ADDENDUM NO. 04

Date of Issuance: January 7, 2025

Project: **2024 Jersey Village High School Renovation**
 Cypress-Fairbanks Independent School District

Texas Arcadis Inc.
 Project No.: 202319

1 ENLARGED SITE PLAN - PORTABLES
1:180

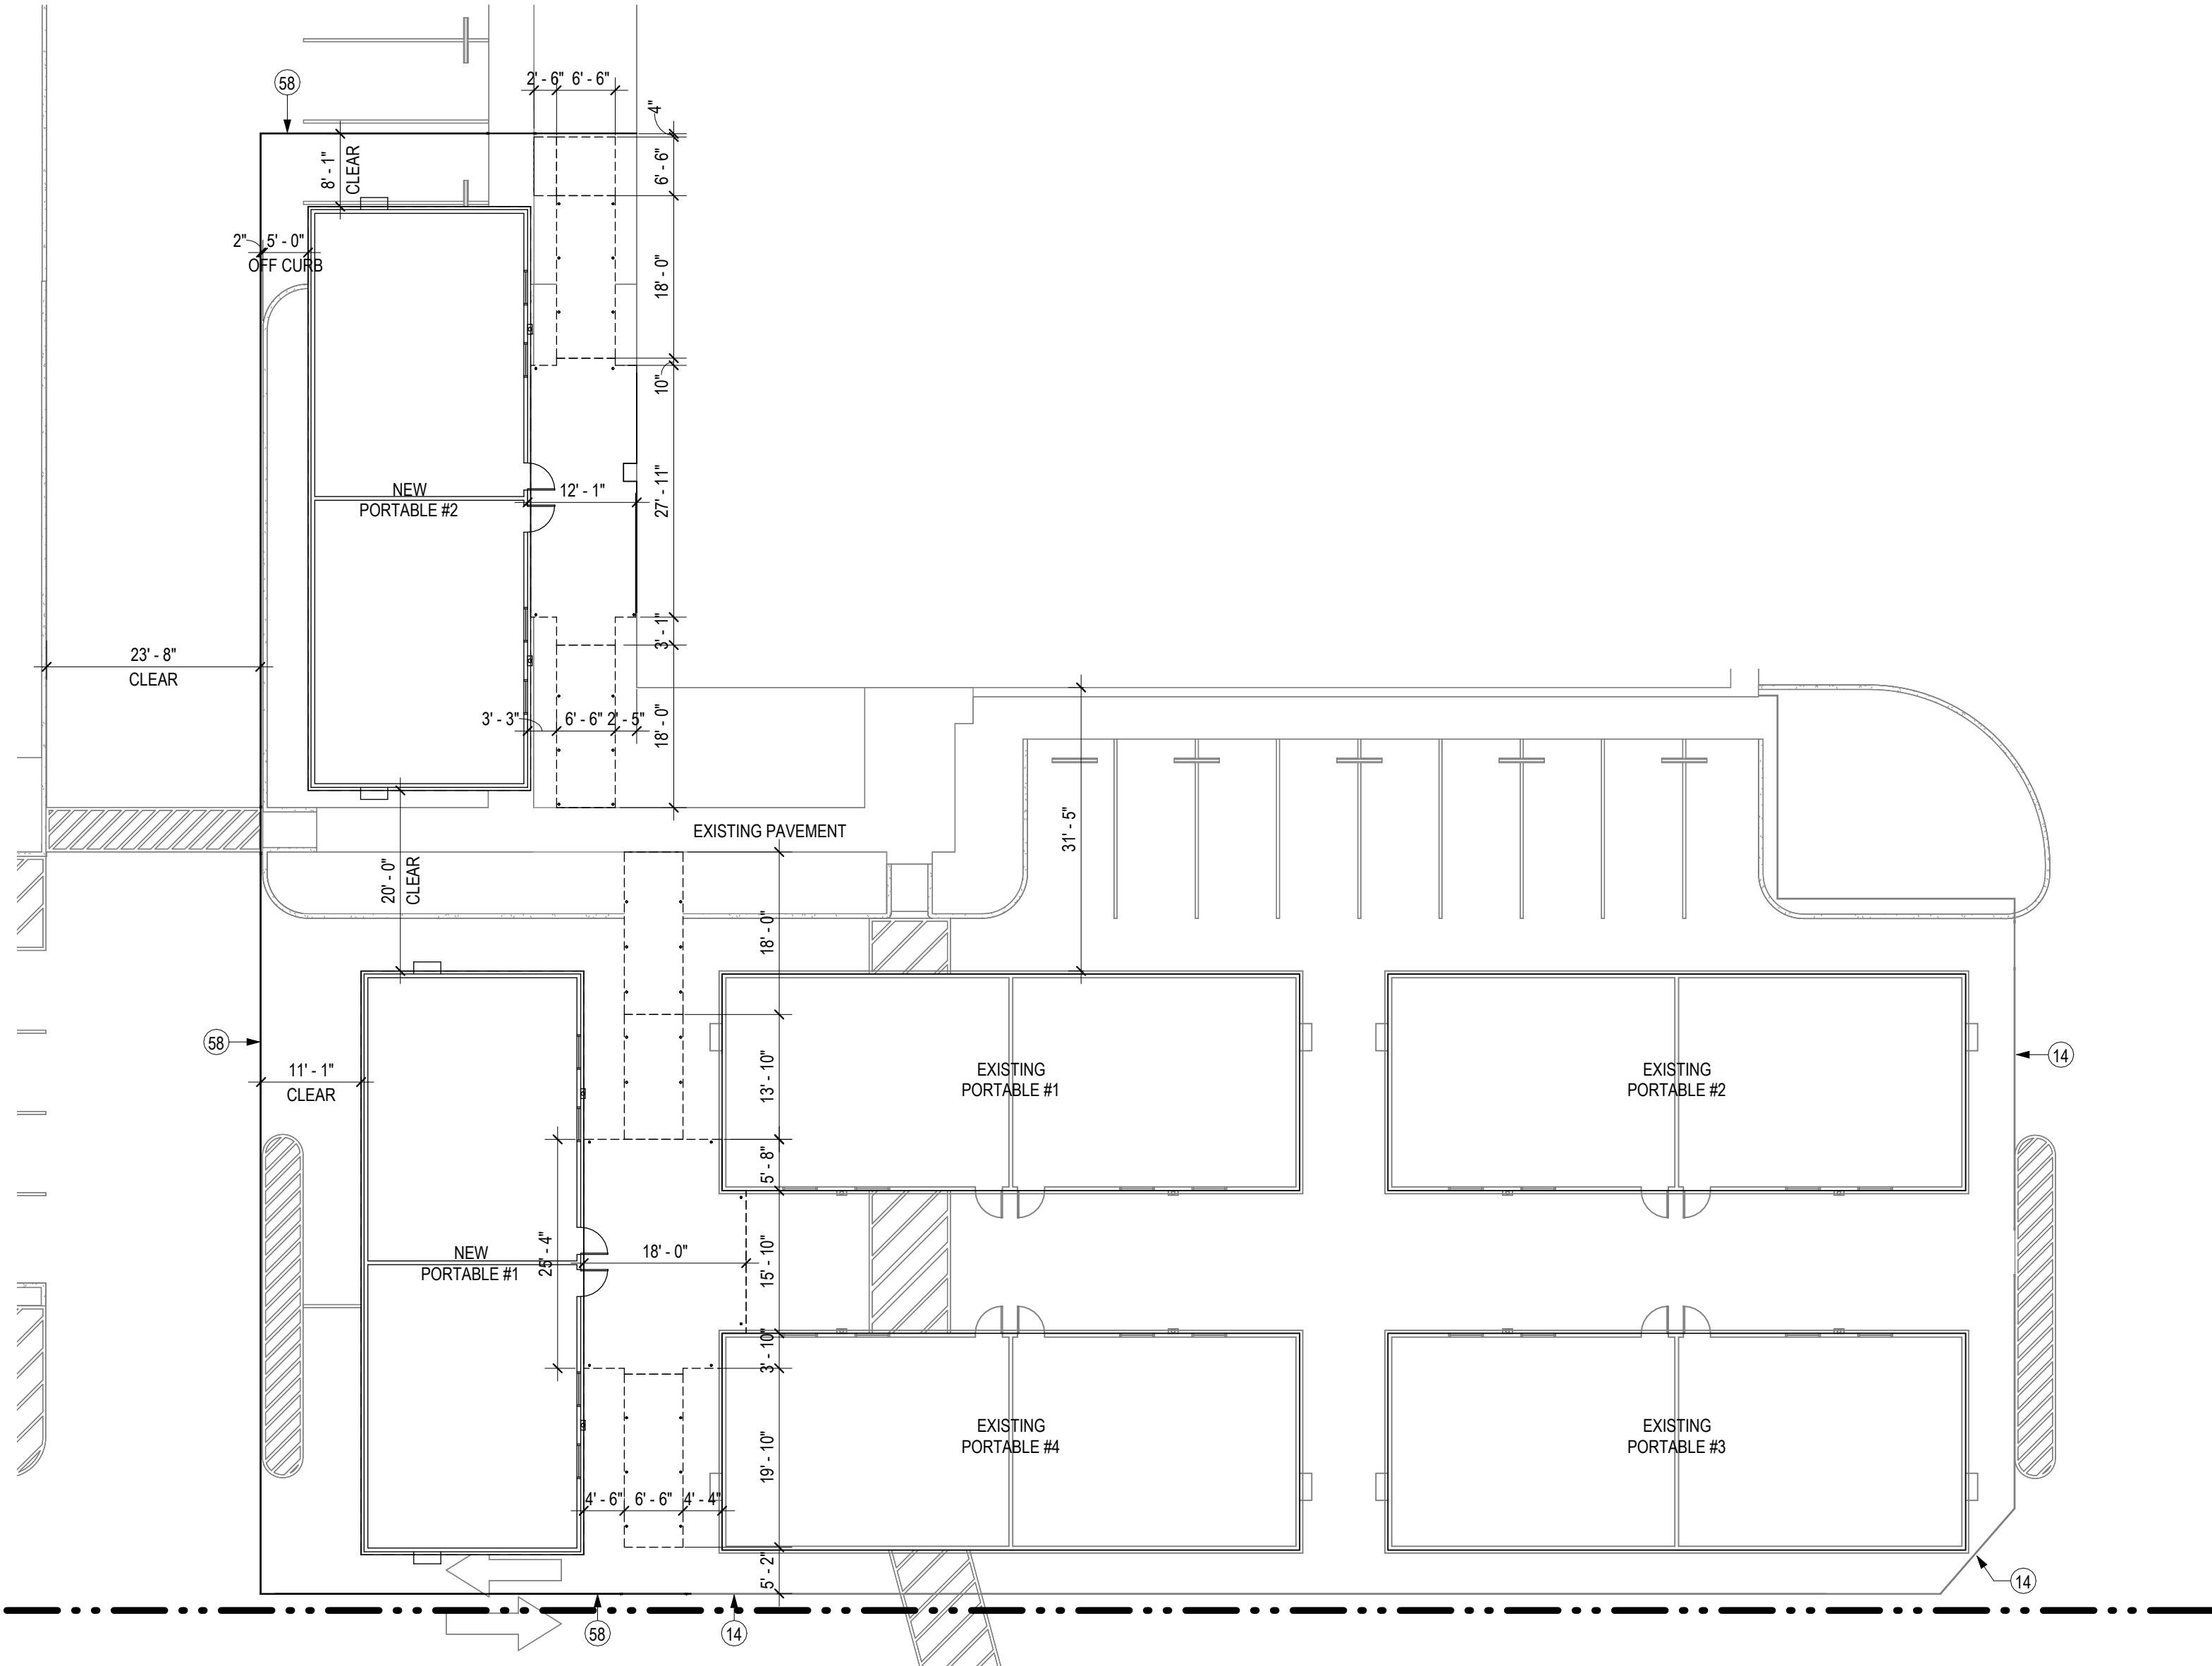
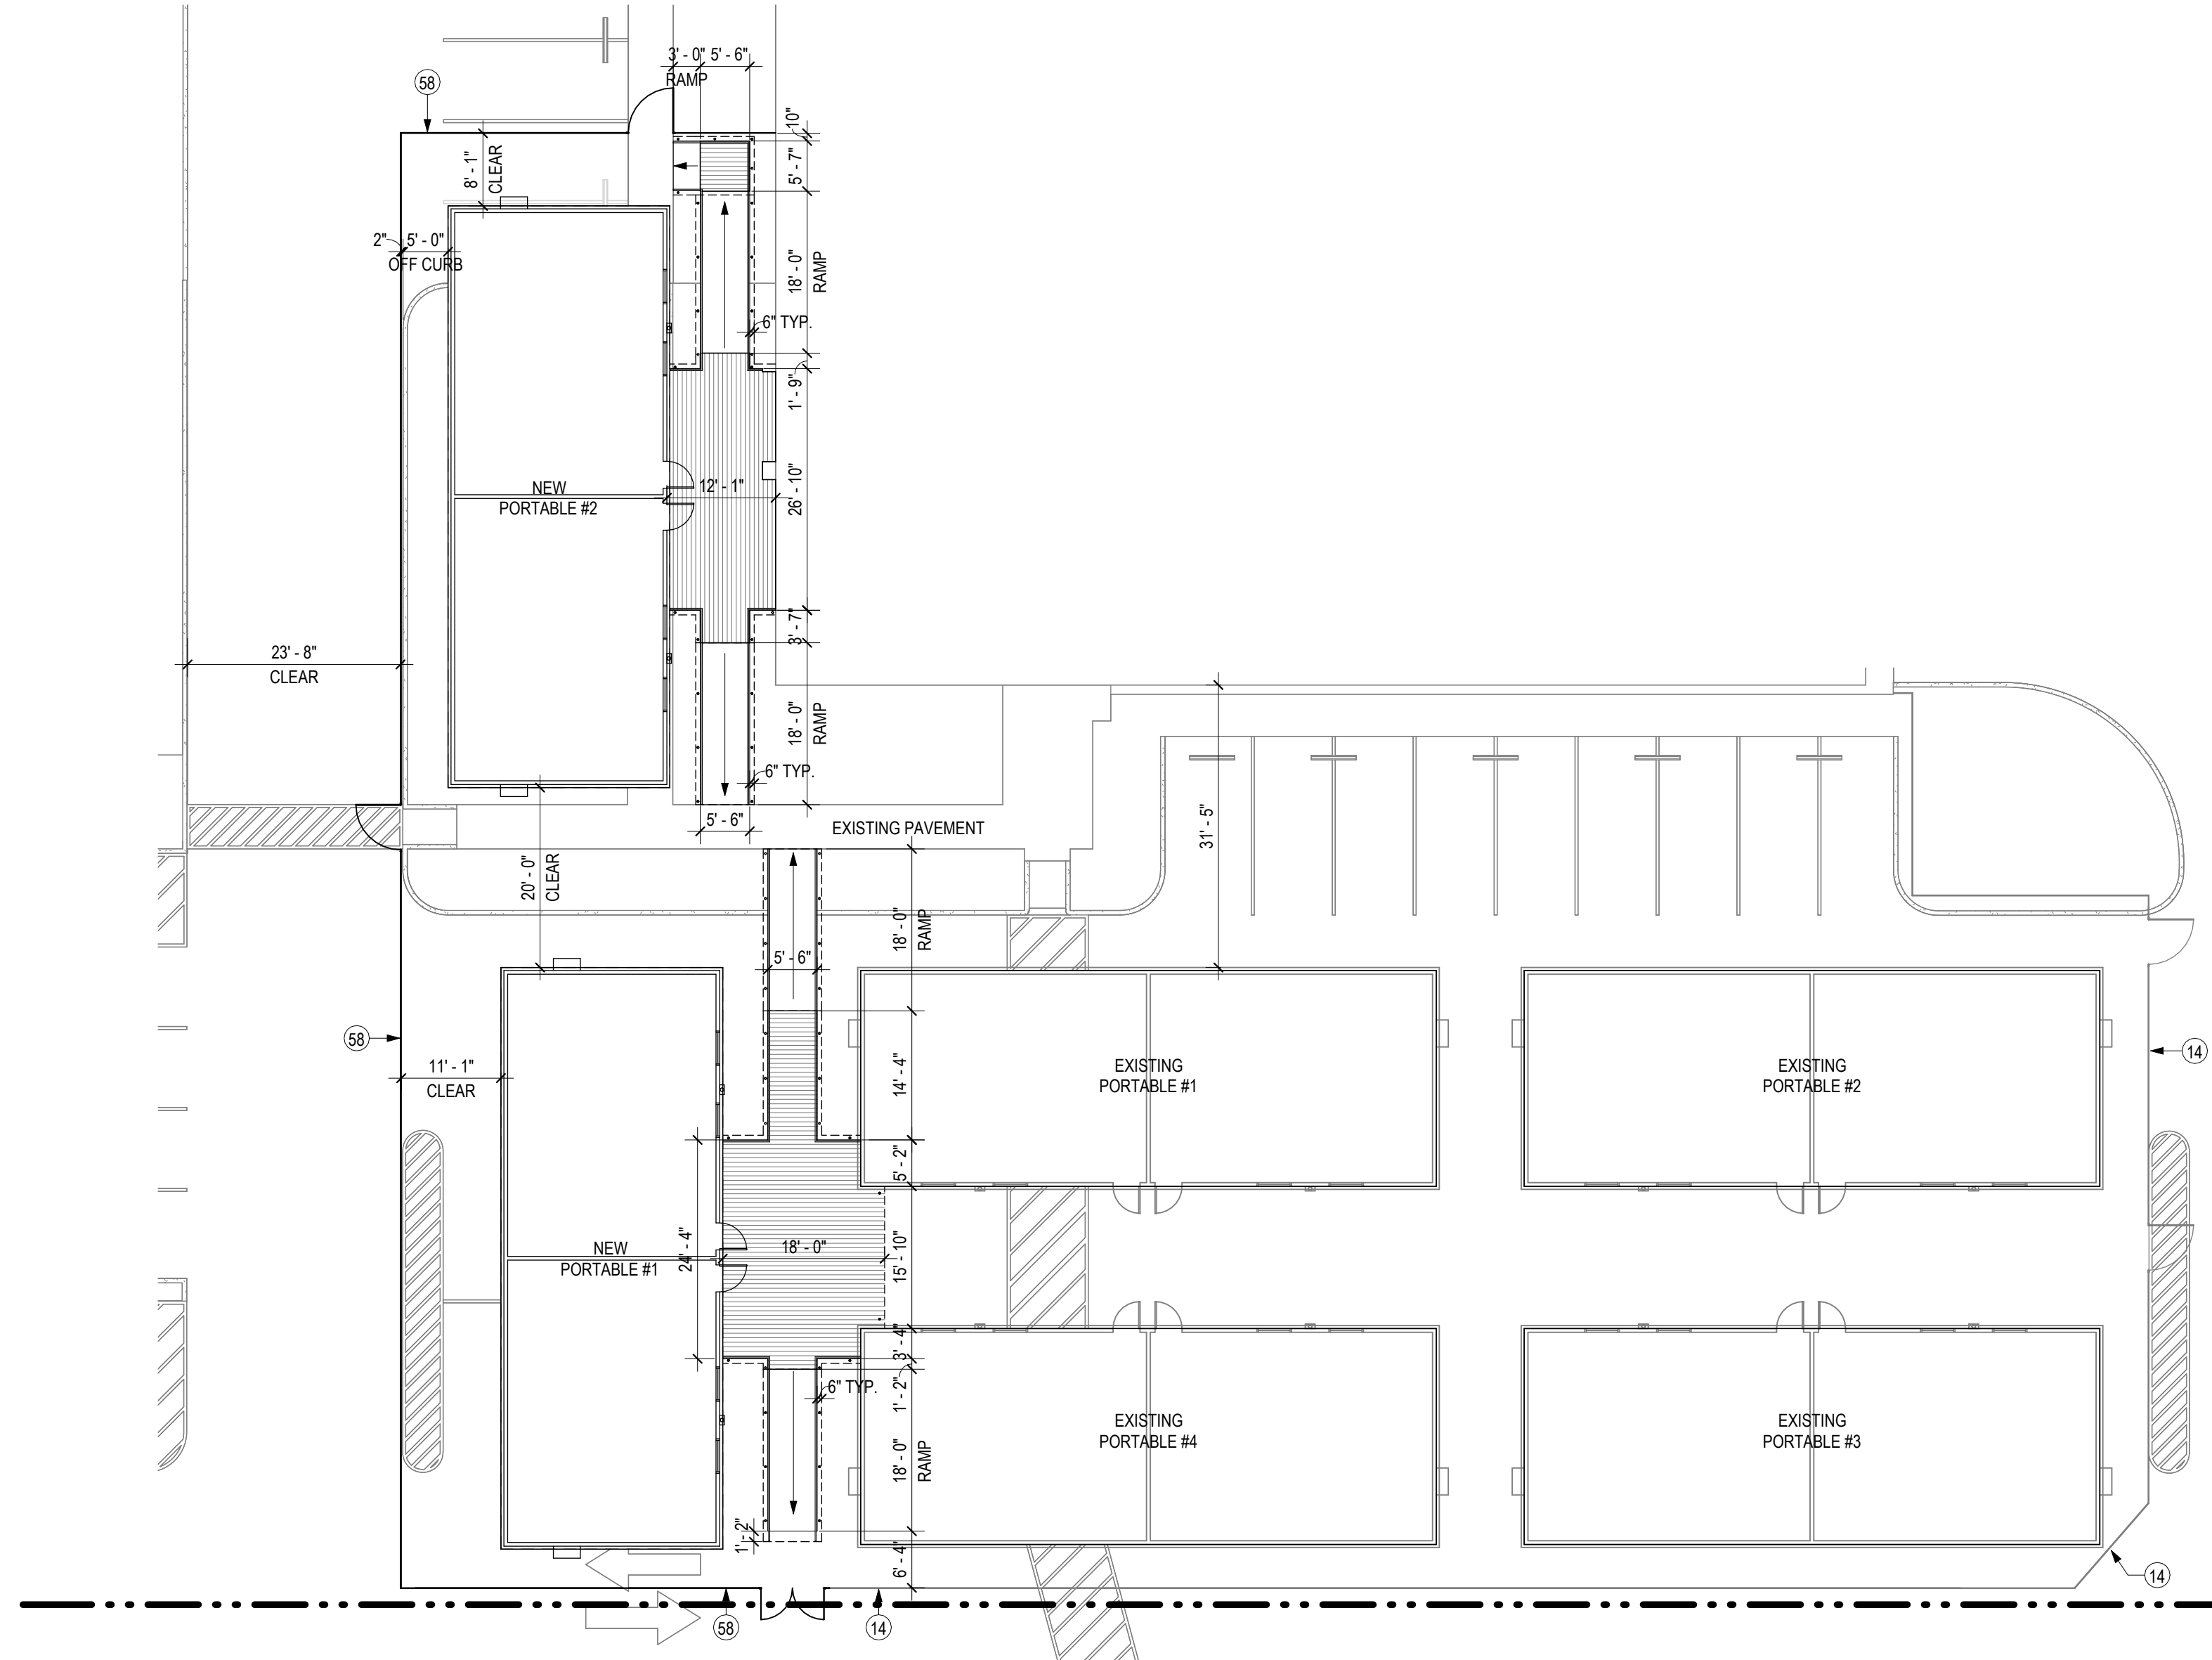
40. Sheet C1.17 - Enlarged Site Plans - Portables
 - a. Issue new sheet in its entirety and provide scope of work.

1 AREA 'P1' - FLOOR PLAN
1/8" = 1'-0"

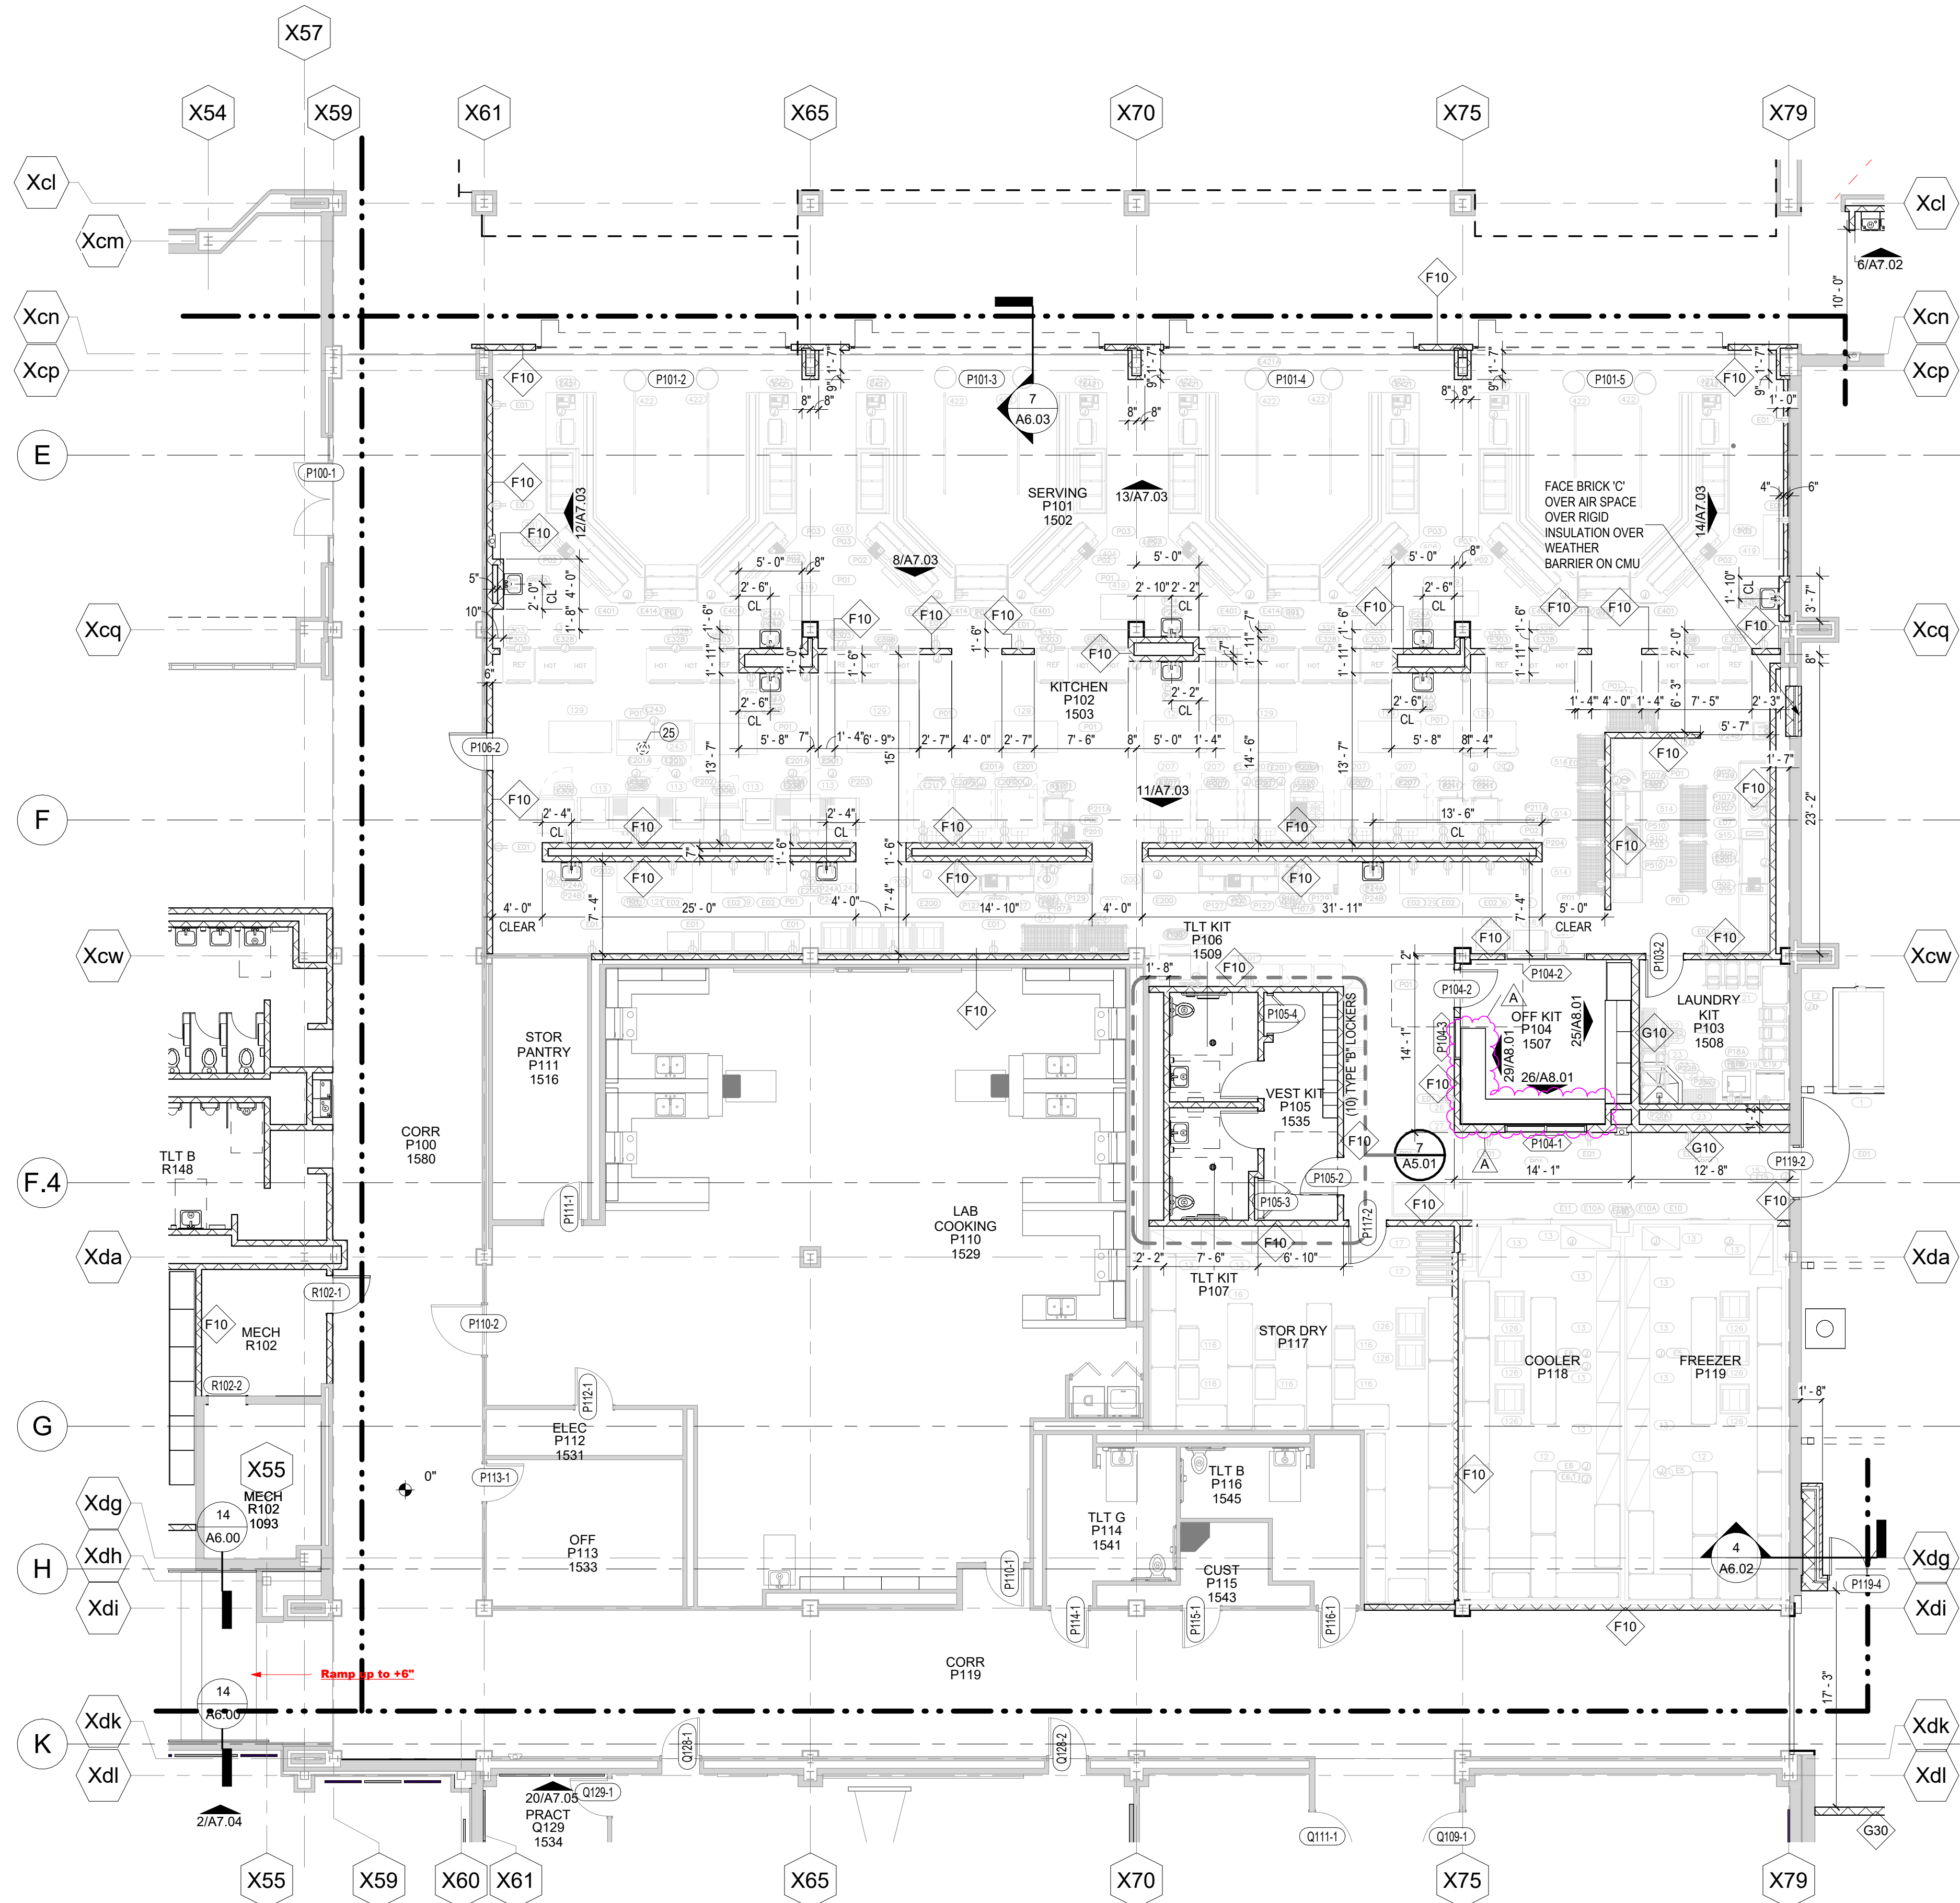
31. Sheet A2.14 – Area ‘P1’ 1st Floor Plan
 - a. Revise room P104 OFF KIT – casework elevation and details
